ROCKWELL-STANDARD CORPORATION
TRANSMISSION AND AXLE DIVISION
DETROIT 32, MICHIGAN

TECHNIC AID

TANDEM DRIVE UNITS

UNBUSHED DIFFERENTIAL PINIONS

INCORPORATING TAPERED BEARINGS IN "ALUMINUM" DRIVE UNITS

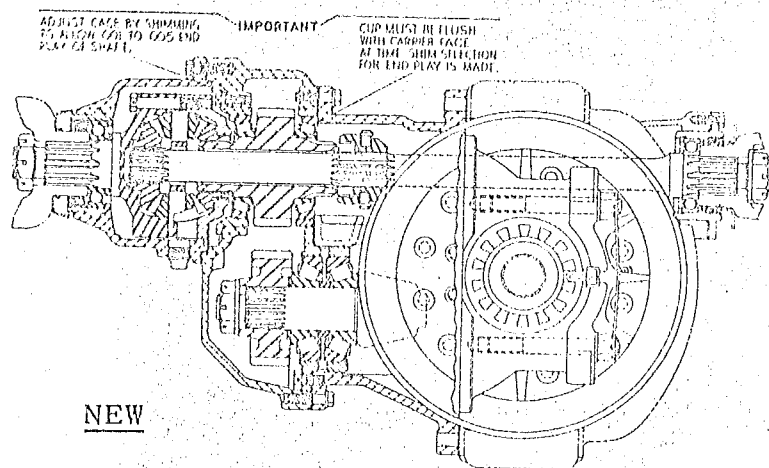
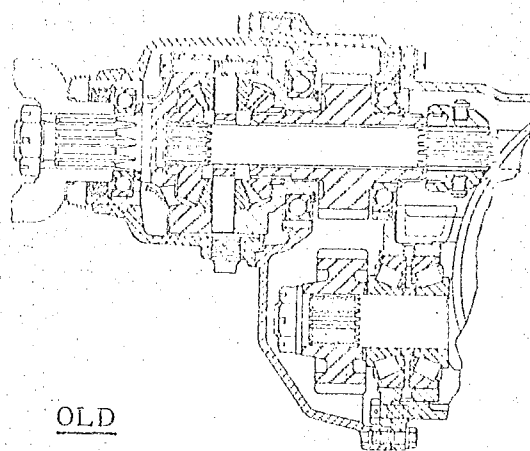
We have released a new "Aluminum" version of the SLHD and SQHD Tandem in which the Upper Helical Gear, in the forward carrier, is mounted on tapered roller bearings.

The earlier drive units can be reworked to incorporate tapered bearings by installing the following parts:

<u>Part</u>	<u>Pieces</u>	<u>Part Number</u>	<u>Remarks</u>
Adapter case	1	3280-C-3253	
Upper Helical Gear	1	3892-P-2044	
Upper Helical Gear Rear Bearing Cup	1	29630	
Upper Helical Gear Bearing	2	29675	
Tapered Bearing Cage Assembly	1	A-3226-C-237	Contains forward bearing cup
Shims (.003")	(As Required)	2203-R-3008 2203-S-3009	Use shims to obtain .001-.005" endplay in gear assembly
Capscrew	6	S-269-D	Use soft lockwire to secure

<u>Part</u>	<u>Pieces</u>	<u>Part Number</u>	<u>Remarks</u>
Inter-Axle Differential Case Ass'y	1	A3-3235-R-564	Forward and Rear Case halves with bushing in rear half.
Inter-Axle Differential Rear Side Gear	1	2234-B-340	Longer hub than old side gear
Adapter & Carrier Gasket	1	2208-H-450	
Inter-Axle and Adapter Gasket	1	2208-E-447	
Shift housing Gasket	1	2208-D-446

In assembly, tighten bearing cage capscrews to 35-40 lb. ft. torque and insert lockwire.

NEW INPUT BEARING CAGE

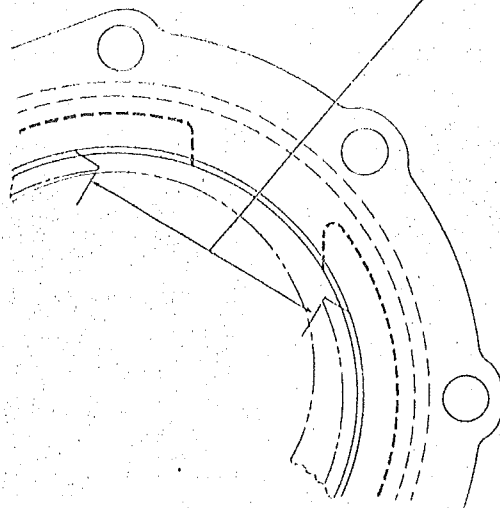
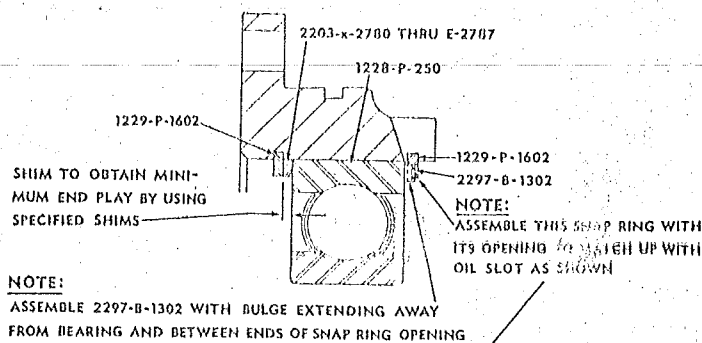
We have redesigned the Input Bearing Cage of the SRHD and SSHD forward rear axle to improve lubrication of the input bearing. The improved lubrication is accomplished by an oil slot in the cage which picks up splashed differential oil and channels it into the oil baffle.

QTY.	NEW PART NUMBER	DESCRIPTION	OLD PART NUMBER	REMARKS
1	3226-Z-182	Input Bearing Cage	Same	Added oil slot
1	2297-B-1302	Oil Baffle		New part added to catch oil for input bearing
2	1229-P-1602	Lockring	Same	Opening widened to correspond with oil slot in cage
1	2203-X-2780 thru E-2787	Shims	Same	No change
1	1228-P-250	Ball Bearing	Same	No change

- A. Install new inner 1229-P-1602 Lockring in the bearing cage. Position the opening toward the oil slot in the cage.
- B. Place the 2297-B-1302 Oil Baffle in the cage with the bulge between the opening in the lockring.
- C. Using a suitable driver, install the 1228-P-250 Ball Bearing.
- D. Position one (1) Bearing Shim against the Ball Bearing. Select a Shim (2203-X-2780 thru E-2787) which will provide a minimum of bearing endplay.
- E. Install the outer 1229-P-1602 Lockring in the cage and check the bearing endplay.

Figure 1

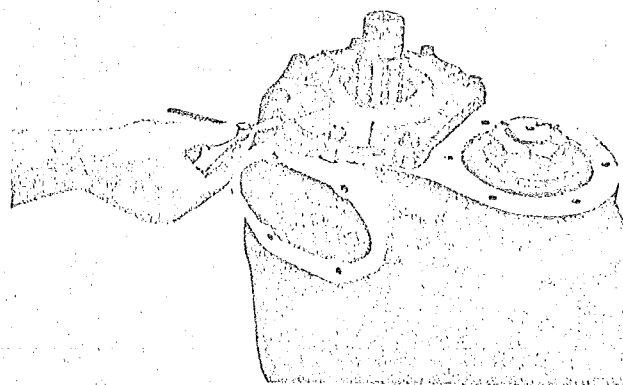
3. Check gap with feeler gauge. Subtract .003 " - .006 " from the amount of gap. This will be the thickness of the shims to be used (Figure 1).

Figure 2

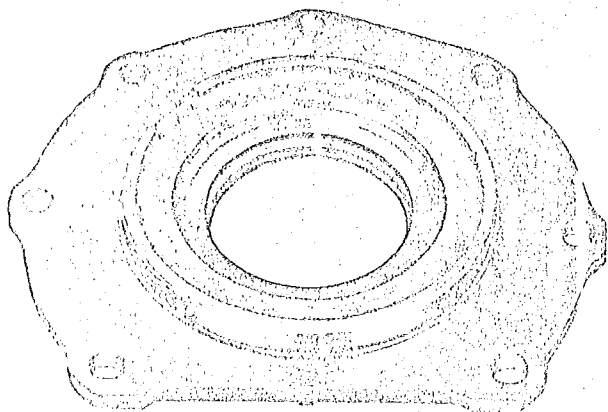
5. Position shims on cover and place rubber "O" ring over the cover pilot next to the shims, (Fig. 2).*

Figure 3

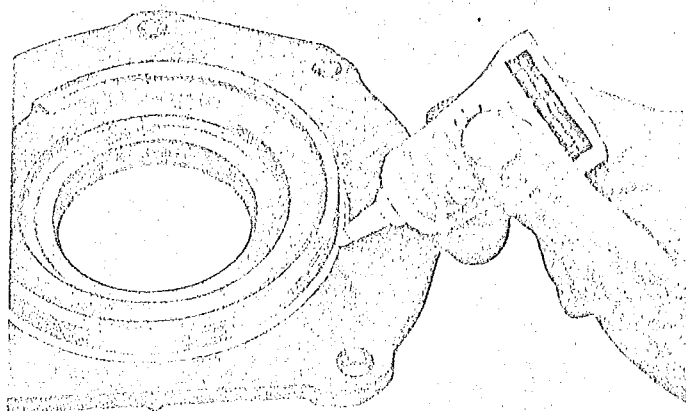
If RTV Silastic is being used, cut applicator at point where it measures approximately 1/8 inch across the outside. Apply a uniform bead of Silastic in the corner at the cover pilot and the face of the shim. Hold the end of the applicator at a 45° angle against the pilot (Figure 3) and the shim and use it as a forming tool while squeezing the tube. (Do not apply "extra" Silastic as this will merely complicate disassembly at a later date.) Allow the Silastic to set for one to two hours to obtain a partial cure.
